DART+ West Project
Section C: Barberstown to
Maynooth Depot

Stage 1 Road Safety Audit

Document Ref:	P22-021-PSW3-RP-001
----------------------	----------------------------

Location: Drawing no. MAY-MDC-HRW-SC07-DR-Z-0001-C (Rev. V05)

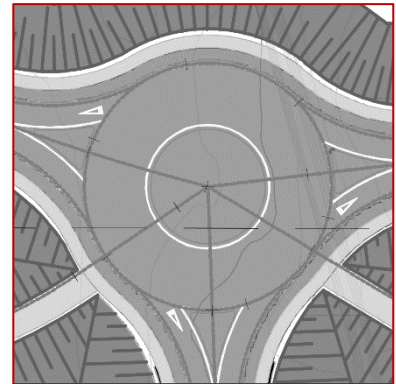
Summary: Large vehicles travelling through the roundabout junction may overhang pedestrian footpaths.

Information regarding the swept path of vehicles has not been provided to the Audit Team. Large vehicles (e.g. buses) may overhang the footpath as they manoeuvre through the roundabout, which may increase the risk of a collision with a pedestrian or cyclist.

A swept analysis should be undertaken to ensure large vehicles do not overhang pedestrian and/or cyclist facilities as they manoeuvre through the roundabout junction.

3.1.1	Yes	Yes		
3.1.2	Yes	Yes		
3.1.3	Yes	Yes		
3.1.4	Yes	Yes		
3.1.5	Yes	Yes		
3.1.6	Yes	Yes		
3.1.7	Yes	Yes		
3.2.1	Yes	Yes		
3.2.2	Yes	Yes		
3.2.3	Yes	Yes		
3.3.1	Yes	Yes

Location: Drawing no. MAY-MDC-HRW-SC07-DR-Z-0001-C (Rev. V05)

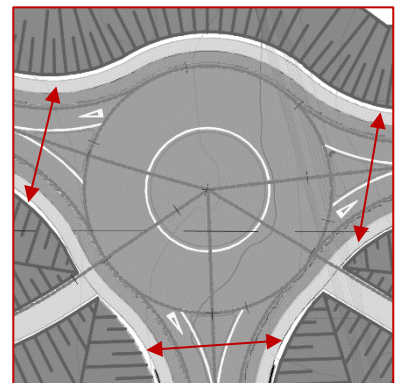
Summary: No pedestrian crossing indicated at the approaches to the R148 roundabout.

No pedestrian crossings are indicated at the proposed R148 roundabout layout. The proposed scheme can be expected to attract pedestrians to the area, many of which may wish to travel towards the surrounding amenities. A failure to provide crossing facilities along expected pedestrian desire lines could result in pedestrians, particularly mobility and visually impaired pedestrians, being unable to safely and independently navigate the proposed road layout.

Provide safe crossing locations on pedestrian design lines.

Location: Drawing no. MAY-MDC-HRW-SC07-DR-Z-0001-C (Rev. V05)

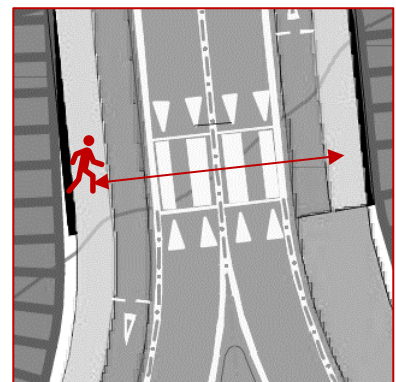
Summary: No safe access route between footpaths at the proposed raised table location.

A raised table is indicated at the southbound approach of the L5041 roundabout. However, to access the opposite footpath, pedestrians would be required to cross the cycle track where no crossing has been indicated. A lack of a formal crossing facilities may lead to an increased risk of pedestrians being struck by cyclists when attempting to cross the carriageway.

The segregated pedestrian /cycle track should transition into a shared use footway either side of the crossing. Additionally, tactile paving will be required at the pedestrian crossing.

Location: Drawing no. MAY-MDC-HRW-SC07-DR-Z-0001-C (Rev. V05)

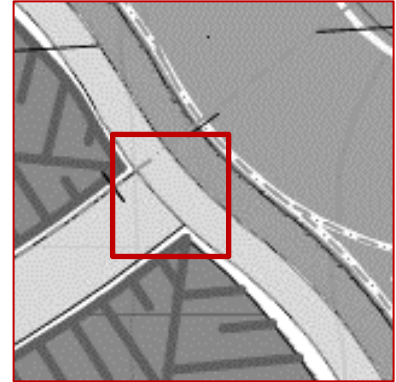
Summary: Visually impaired pedestrians may find it difficult to navigate the shared surfaces safely and independently.

A number of intersections between shared surfaces and segregated footpaths are shown. However, no tactile paving has been indicated at these intersections, resulting in visually impaired pedestrians not being advised/warned that they are entering a section of path which includes segregated pedestrian/cyclist facilities. This may increase the risk of visually impaired pedestrians inadvertently entering the cycle track, where they are at increased risk of being struck by a cyclist.

Tactile paving (e.g. “Ladder & Tramline”) should be provided at the interface between shared and segregated facilities.

Location: Drawing no. MAY-MDC-HRW-SC07-DR-Z-0001-C (Rev. V05)

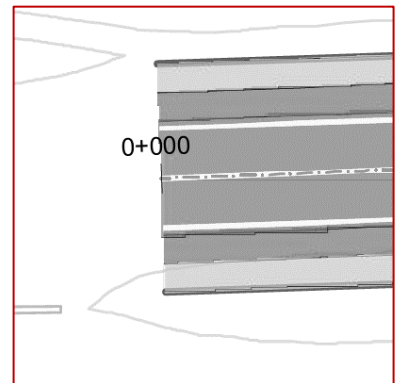
Summary: It is unclear if the proposed upgrade works sufficiently tie-into the existing road network.

As part of the L5041/R148 realignment works, amendments to the existing road layout have been indicated. It is unclear how the segregated pedestrian footways and cycleway will be tied into the existing R148 and L5041.

If the proposed upgrades do not sufficiently tie-into the existing road layout there is a risk that drivers will be directed into adjacent, or opposing, traffic lanes where there is an increased risk of side swipe or head-on collisions respectively.

Additionally, if safe transitions between the new cross section and the existing cross section are not fully considered at this early stage, there is a risk that locked-in land and road constraints lead to unsafe road layouts being developed at the next design stage.

Ensure the amended sections of carriageway and NMU (Non-motorised User) facilities sufficiently align with the existing road layout at the scheme tie-ins ensuring a smooth transition between the upgraded sections of carriageway to the old sections of carriageway.

Location: Drawing no. MAY-MDC-HRW-SC07-DR-Z-0001-C (Rev. V05)

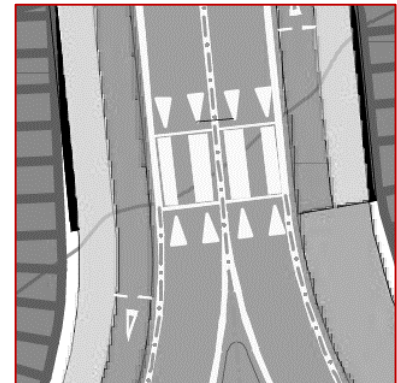
Summary: Unclear if the circulating carriageway will sufficiently drain surface water.

Information regarding the proposed drainage measures within the circulating carriageway have not been indicated. It is therefore unclear if the carriageway will sufficiently shed surface water. A failure to provide sufficient drainage measures could lead to ponding on the carriageway resulting in loss of control type collisions during wet or icy weather.

Ensure the circulating carriageway will be adequately drained.

Location: Drawing no. MAY-MDC-HRW-SC07-DR-Z-0001-C (Rev. V05)

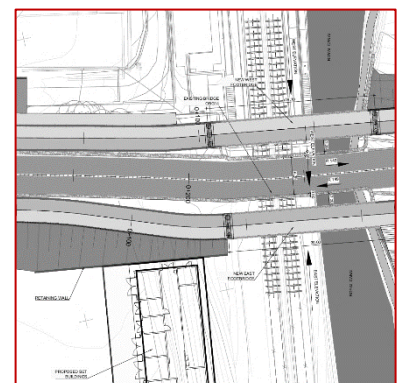
Summary: Unclear if there is sufficient drainage provision at raised table locations.

Drainage provision has not been indicated at the raised table. Should inadequate drainage measures be provided, this could lead to ponding on the footpath or carriageway resulting in slips, trips and falls during wet or icy weather.

Ensure that the footpath and carriageway is adequately drained, particularly at locations where raised tables are provided and where any low spots may exist.

Location: Drawing no. MAY-MDC-HRW-RS12-DR-C-0003-C (Rev.V01)

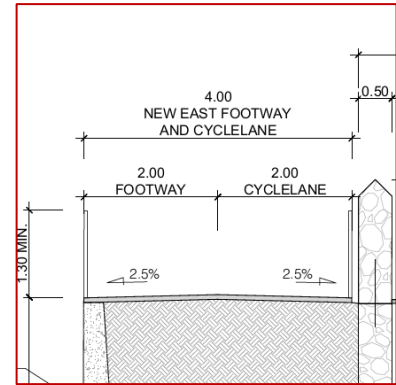
Summary: The vertical and horizontal alignment may lead to possible side-swipe collisions.

The combination of the steep vertical gradients, horizontal alignments and the narrow lanes may lead to poor lane discipline, and possible side-swipe and material damage collisions as opposing drivers cross the bridge.

Swept path analysis should be undertaken to confirm that opposing HGVs can safely pass each other on the structure. Additionally, traffic calming measures should be provided to passively control vehicle speeds on approach to the Leixlip Confey Bridge, along with warning signs to be provided advising of steep gradients and road narrowing.

Location: Drawing no. MAY-MDC-STR-RS12-DR-C-0003-C (Rev. V01)

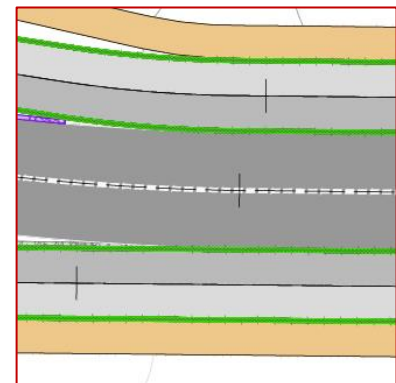
Summary: No difference in level is shown between the cycleway and footpath.

There is no difference in level between the cycleway and the footpath in the cross sections provided. This may result in visually impaired pedestrians inadvertently entering the cycleway resulting in conflicts with cyclists.

A level difference and kerbed upstand should be provided between the footpath and the cycleway.

Alternatively, contrasting materials should be used in the footway and cycleway to provide colour contrast, including a solid white line separating the two uses.

Ladder and tramline tactile paving should be provided at the start and end of the segregated facilities.

Location: Drawing no. MAY-MDC-HRW-RS12-DR-C-0003-C (Rev. V01)

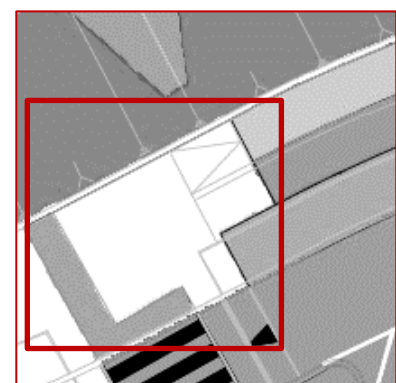
Summary: It is unclear how the proposed upgrade works will tie-into the existing road network.

It is unclear how the segregated ped/cycle facilities will tie into the existing road network up and downstream of the bridge construction.

If safe transitions between the new cross section and the existing cross section are not fully considered at this early stage, there is a risk that locked-in land and road constraints lead to unsafe road layouts being developed at the next design stage.

Ensure the amended sections of carriageway and NMU facilities sufficiently align with the existing road layout at the scheme tie-ins, ensuring a smooth transition between the upgraded sections of carriageway to the old sections of carriageway.

Location: Drawing no. MAY-MDC-HRW-LC05-DR-C-0100-C (Rev. V01)

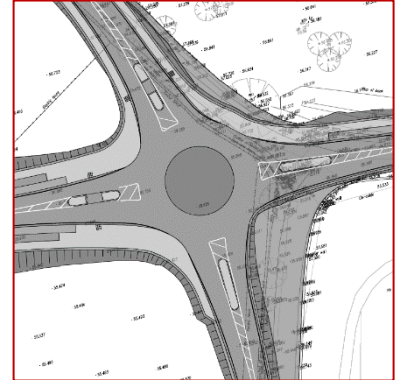
Summary: Tactile paving has not been indicated at the transitions between shared surfaces and segregated footways.

Tactile paving (e.g. ladder and tram) has not been indicated at the start and end of shared and segregated surfaces. This could lead to visually impaired pedestrians inadvertently entering the cycle track, or approaching shared surfaces and being unaware of the presence of cyclists, which may increase the risk of pedestrian-cyclist collisions.

Tactile paving (e.g. ladder and tram) should be provided at the interfaces between shared and segregated surfaces.

Location: Drawing no. MAY-MDC-HRW-LC05-DR-C-0100-C (Rev.V01)

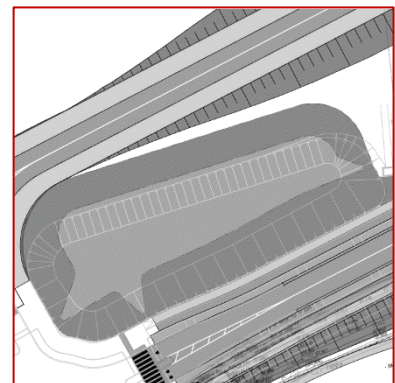
Summary: Unclear if the proposed roundabout can safely accommodate the swept path of large vehicles.

Information regarding the swept path of vehicles turning at this roundabout has not been provided to the Audit Team and it is therefore unclear if these vehicles can safely undertake U-turn manoeuvres at these locations. If this roundabout cannot accommodate the swept path of large vehicles there is a risk that they may overhang the footpath as they manoeuvre through the roundabout which may lead to a collision with a pedestrian or cyclist or collisions with items of roadside furniture.

A swept analysis should be undertaken to ensure all vehicles can be safely accommodated at the roundabout junction.

Location: Drawing no. MAY-MDC-HRW-LC05-DR-C-0100-C (Rev.V01)

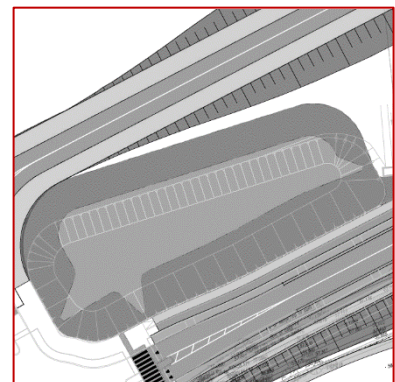
Summary: Maintenance access to attenuation ponds may lead to operatives parking their vehicles at unsafe locations where they may present hazards to other road users.

An attenuation or stormwater pond has been indicated. It is unclear how maintenance operatives will access the pond, or where they will park when servicing the pond. Insufficient or inappropriate access may lead to maintenance operatives parking their vehicle at unsafe locations such as within the carriageway, at accesses or on the footpath or cycle track where it will present obstacles to other road users.

Safe access and parking for maintenance operatives should be provided at proposed pond.

Location: Drawing no. MAY-MDC-HRW-LC05-DR-C-0100-C (Rev.V01)

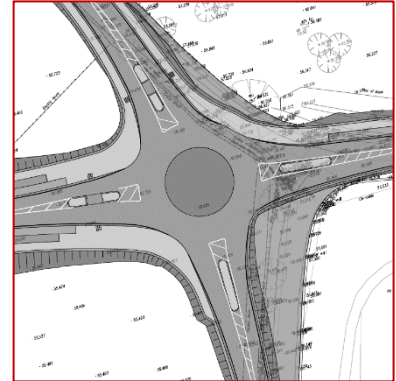
Summary: Edge protection has not been indicated at the proposed attenuation pond.

An attenuation or stormwater pond has been indicated within the proposed scheme. Edge protection has not been indicated at the pond. In some instances, this pond is located close to footpaths, which could increase the risk of pedestrians, especially small children, gaining access to the pond, where there is a risk of falling from height and possible drowning.

Additionally, a vehicle restraint system has not been indicated. The absence of a vehicle restraint system could result in an errant vehicle entering the pond, leading to increased injury severity for vehicle occupants.

Edge protection and vehicle restrain systems should be provided at the pond.

Location: Drawing no. MAY-MDC-HRW-LC05-DR-C-0100-C (Rev.V01)

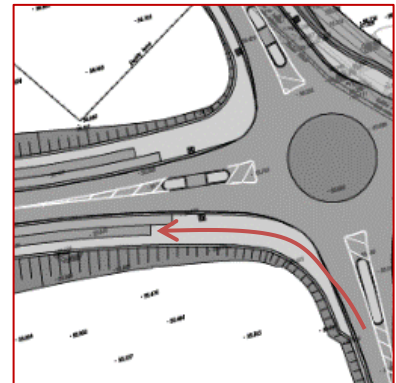
Summary: The splitter island locations may lead to poor lane discipline and possible material damage collisions.

The splitter islands on the approach to the roundabout stop short of the circulating carriageway. As road markings may fade over time, the junction layout may become less defined, resulting in poor lane discipline, and turning traffic on the circulating carriageway possibly over-running the yield line, which may increase the risk of side-on collisions.

The physical splitter islands should be extended to the yield line on all four approaches.

Location: Drawing no. MAY-MDC-HRW-LC05-DR-C-0100-C (Rev.V01)

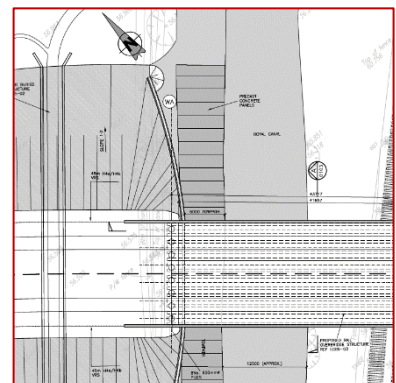
Summary: Cyclists may attempt to mount/dismount a full height kerb when accessing the off-road cycle track.

An off-road cycle track is provided at the western arm of the Milestown Roundabout. However, it is unclear how northbound cyclists travelling within the carriageway at the southern arm of the roundabout will gain access to the off-road cycle track at the western arm. The absence of cycle facilities connecting the off-road cycle track with the carriageway may lead to personal injury collisions where cyclists attempt to mount/dismount a full height kerb.

Cyclist facilities (e.g. ramp access) should be provided upstream of the roundabout, allowing cyclists to safely access the off-road cycle track in advance of the roundabout.

Location: Drawing no. MAY-MDC-HRW-LC05-DR-C-0201-C (Rev.V01)

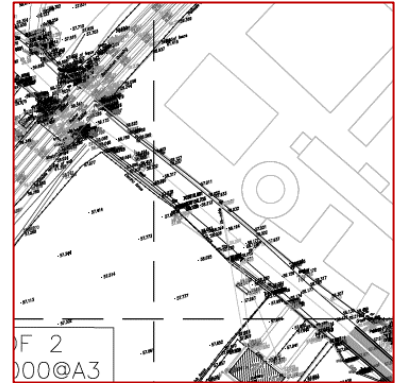
Summary: Risk of pedestrians and cyclists falling from height.

The shared pedestrian/cyclist track runs parallel to the canal edge. The RSA Team is concerned that a visually impaired pedestrian may be unaware of the canal towpath edge, and inadvertently fall into the canal, where there is a risk of drowning.

Ensure appropriate vegetation is placed along the edge of the canal to prevent pedestrians walking too near the edge, and that a safe minimum width is maintained at all points along the canal.

3.3.2	Yes	Yes		
3.3.3	Yes	Yes		
3.3.4	Yes	Yes		
3.3.5	Yes	Yes		
3.3.6	Yes	Yes		
3.3.7	No	No	Introduction of a verge to the canal would reduce the navigable width of the canal. The design will include a pedestrian guardrail along the section where the verge is removed.	Yes

Location: Drawing no. MAY-MDC-HRW-LC05-DR-C-0100-C (Rev.V01)

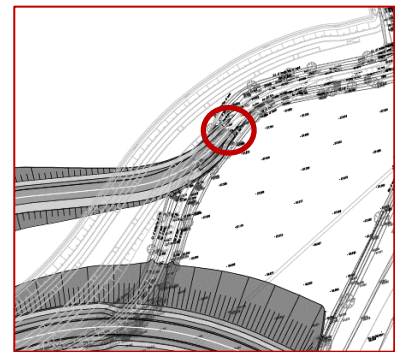
Summary: It is unclear how the carriageway will be terminated on the northern and southern side of the existing Barberstown level crossing after closure.

It is assumed that Milestown Road will be terminated on either side of the existing Barberstown level crossing. It is unclear if there is sufficient space to undertake U-turns at the end of each road. Insufficient space to safely turn a vehicle may increase the likelihood drivers reserving long distance to exit the cul de sac, leading to possible rear-end-shunt or material damage collisions.

A turning head should be provided at the end of each road, ensuring drivers have sufficient space to turn and exit the cul de sac.

3.3.8	No	No	On the southern side, there are adequate existing opportunities for vehicle turn around in close proximity to the level crossing. All land either side of the roadway are in the ownership of one landowner, who intends to petition the LA to close the lane for local access only. Adequate signage indicating a cul de sac and local access only will be provided as part of the DART+ West Project. On the northern side, adequate existing opportunities for vehicle turn around are available.	Yes

Location: Drawing no. MAY-MDC-HRW-LC05-DR-C-0100-C (Rev.V01)

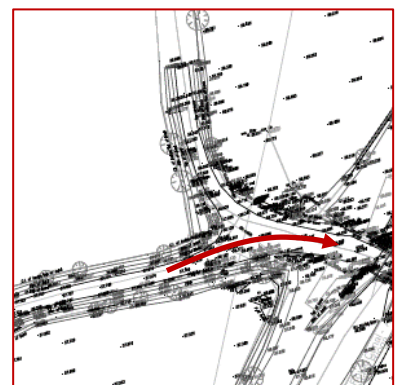
Summary: The proposed tie-in point between the new and old road cross sections is up-stream of a high demand bend.

The local road tie-in is at a high demand bend, where vehicles leave an improved cross section into an area with poor visibility and deficient cross section. Drivers leaving the new road may be unprepared to reduce their speed ahead of the narrow cross section/high demand bend, leading to possible loss of control and head-on collisions.

The new road tie-in should extent further east, to a point that is beyond the high demand bend, ensuring drivers have adequate visibility when transitioning between the new and old cross sections.

3.3.9	Yes	No	The proposed design will be narrowed to the width of the existing	Yes

Location: Drawing no. MAY-MDC-HRW-LC05-DR-C-0100-C (Rev.V01)

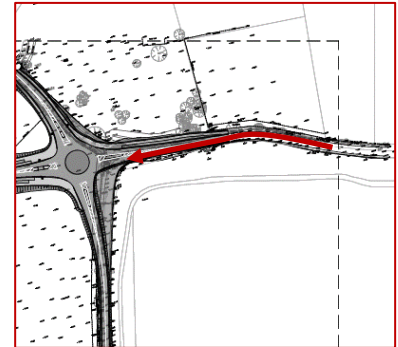
Summary: Poorly defined existing junction between Barberstown Lane North and Barberstown Lane South.

The existing junction between Barberstown Lane North and Barberstown Lane South is located northeast for the proposed Barberstown level crossing. The traffic at this junction is likely to increase due to the proposed works. However, the existing junction alignment and layout is substandard, and may increase the risk of eastbound drivers sighting into the primary road, which may contribute to overshoot collisions.

The existing junction should be revised to provide greater junction definition, and to passively slow vehicles turning into and out of the junction.

Location: Drawing no. MAY-MDC-HRW-LC05-DR-C-0100-C (Rev.V01)

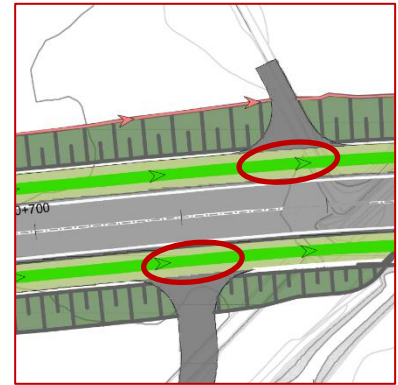
Summary: Westbound drivers may be unaware of the roundabout junction due to the horizontal alignment upstream of the junction.

Westbound drivers may be unaware of the roundabout junction, or possible queues forming at the roundabout, as forward visibility is limited by the horizontal alignment. Insufficient visibility to the roundabout junction may result in drivers failing to reduce their speed accordingly, leading to rear-end-shunt collisions.

The horizontal alignment on the approach to the roundabout should be amended to maximise forward visibility to the junction. Additionally, advance warning signs and road markings should be provided to warn drivers of the junction.

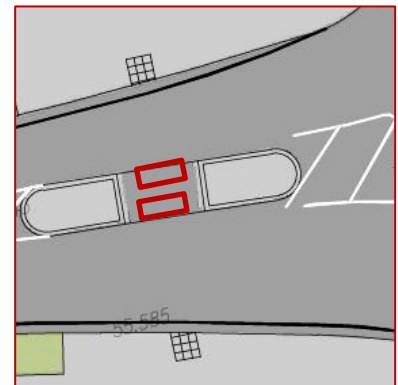
4.1 Grass verges are indicated between multiple side roads and the mainline carriageway at the L5041/R149 realignment works. It is assumed that this is a CAD error, however the drawing should be amended to correctly show the side road junctions connecting with the main road.

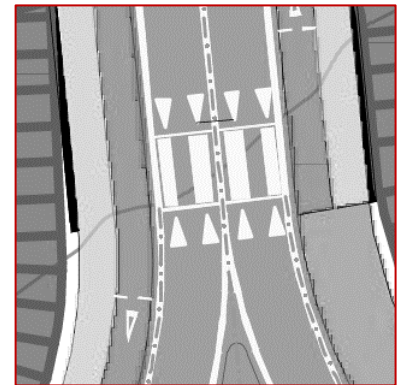
4.2 Tactile paving should be provided within the splitter island.

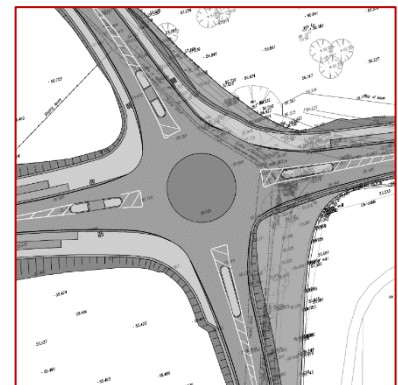
4.3 A raised table with a pedestrian crossing has been indicated across the L5041, however, the type of crossing proposed is unclear (appears to be a Zebra Crossing). An assessment should be undertaken to determine the most appropriate type of pedestrian crossing to use at this location.
